IREDELL COUNTY HEALTH DEPARTMENT

IMPROVEMENT PERMIT / AUTHORIZATION TO CONSTRUCT / OPERATION PERMIT / EXISTING SYSTEM INSPECTION

PERMIT# 13893T PIN# ~~4679318736~~ 4679317550 DATE 11-6-06

SUBDIVISION Kerri Plantation BLOCK / SECTION S LOT 12 LOT AREA 1.17 Acre SITE CLASS. PS DESIGN FLOW 480gpd L.T.A.R. .3

AS BUILT SKETCH

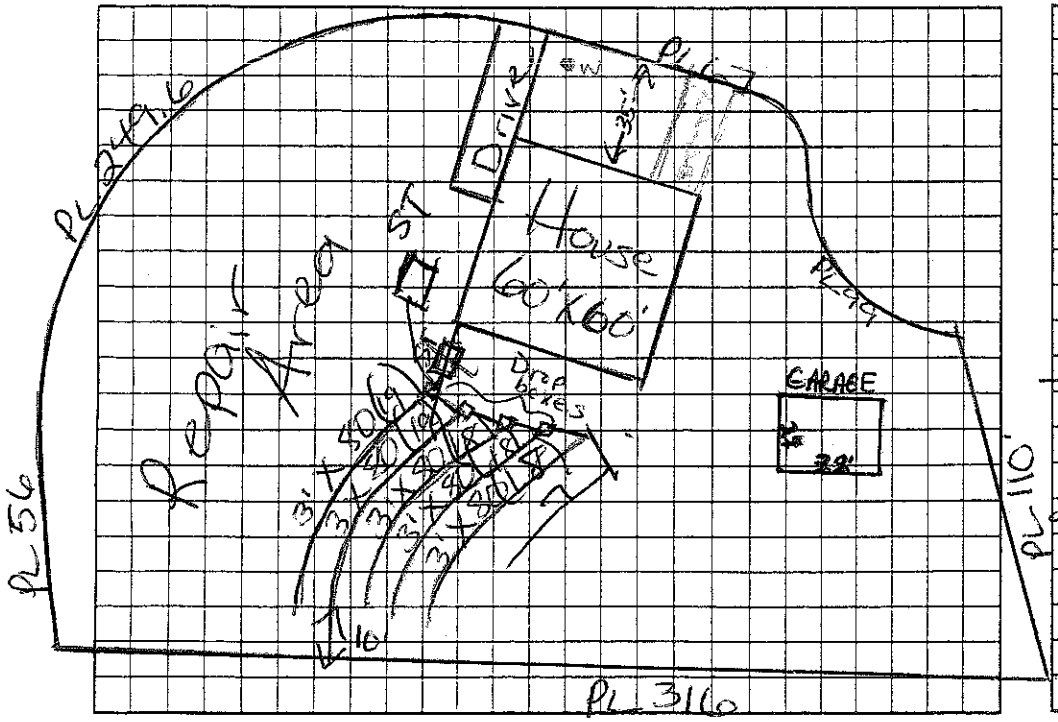
+ Used Quick 4 Infiltrator
+ Installed in 6 lines
Serial distribution
+ Lowest line ~ 28'
+ Supply line ~ 4ft off Patio & 9ft off House

THE PROPOSED DECK (34'x6') ADDITION DOES NOT APPEAR TO IMPACT THE EXISTING SEPTIC SYSTEM. IT WILL REMAIN 5' FROM SEPTIC SUPPLY LINE.

The proposed / existing 24'x 32' GARAGE addition does not appear to impact the existing septic system.
